ONE EARTH SOLAR FARM
EN010159

WEST LINDSEY DISTRICT COUNCIL

RESPONSE TO ISH2 ACTION POINTS

Issue Specific Hearing 2 (ISH2): environmental matters

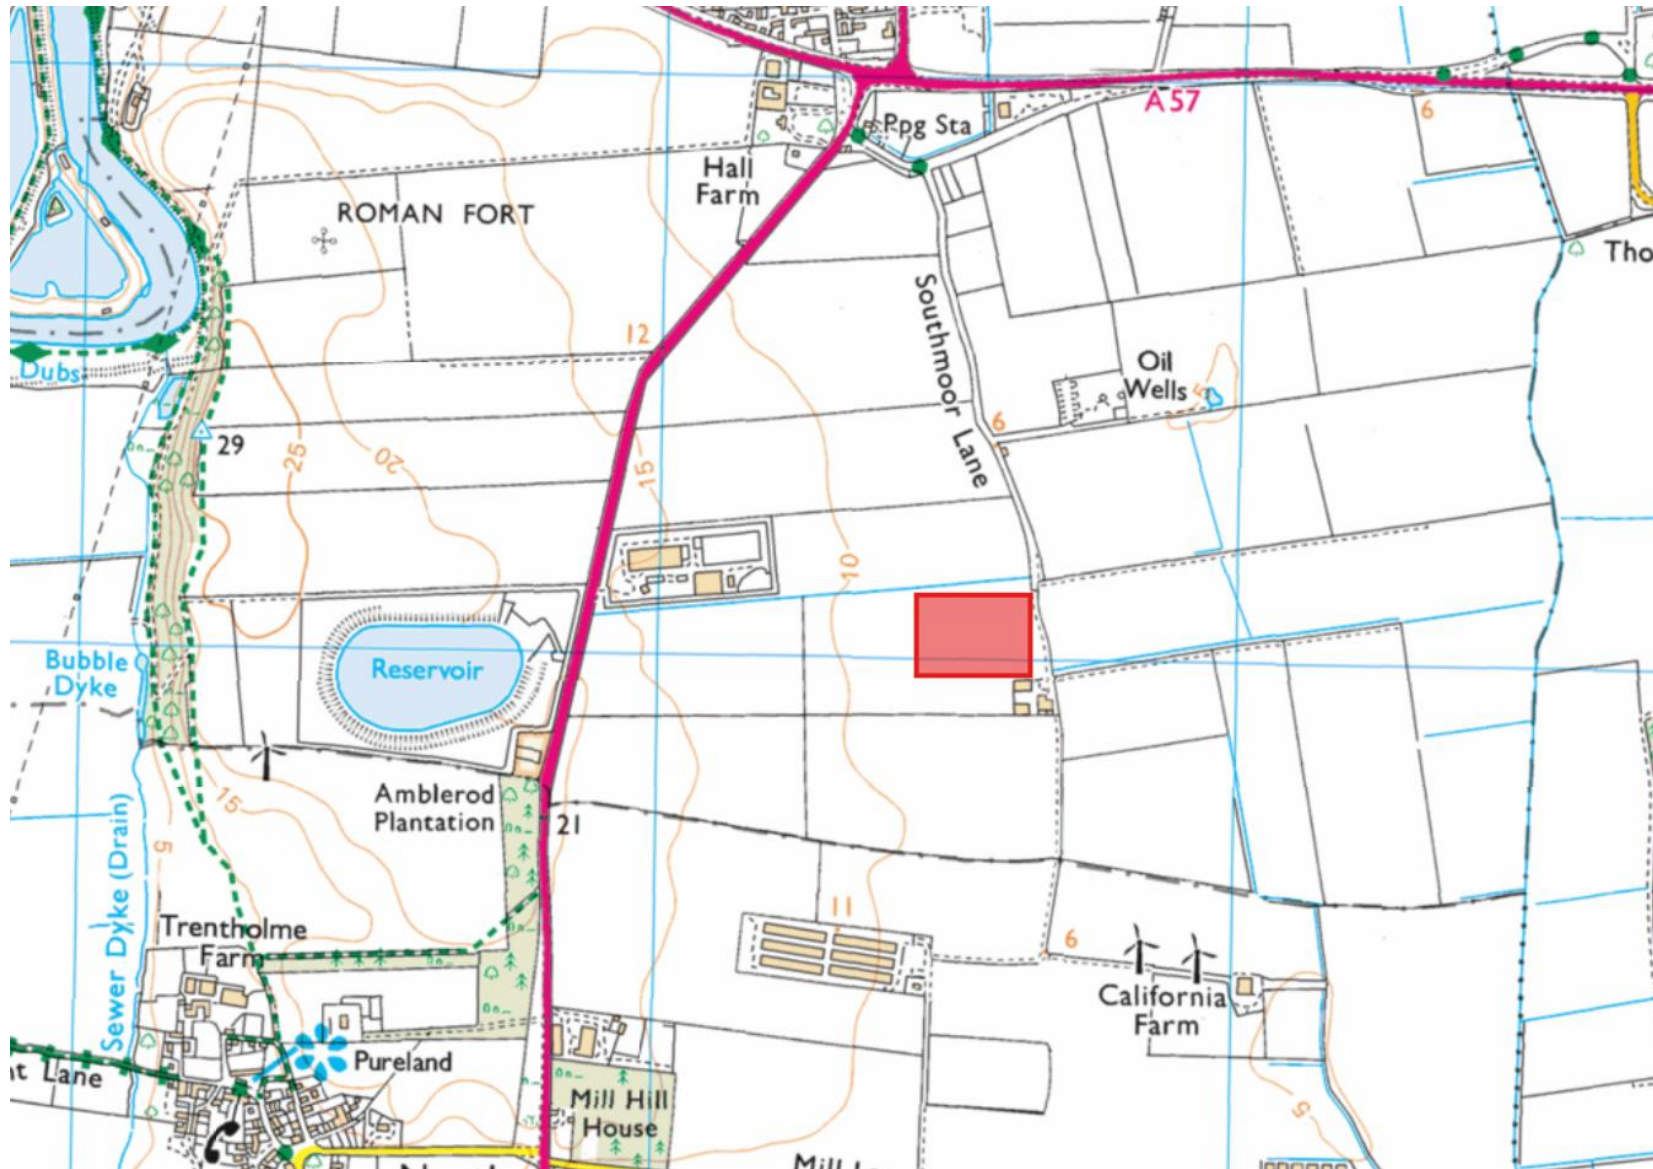
West Lindsey District Council has been working with the applicant's advisors to agree specific siting parameters for a suitable location for the eastern substation, should the DCO be approved. It is the view of WLDC, having reviewed cross section information, that the best location within the area identified by the applicant in the application documents as being for the BESS and substation is shown on the diagram below. WLDC would like to see a similar parameter for the eastern substation included on the certified plans accompanying the DCO.
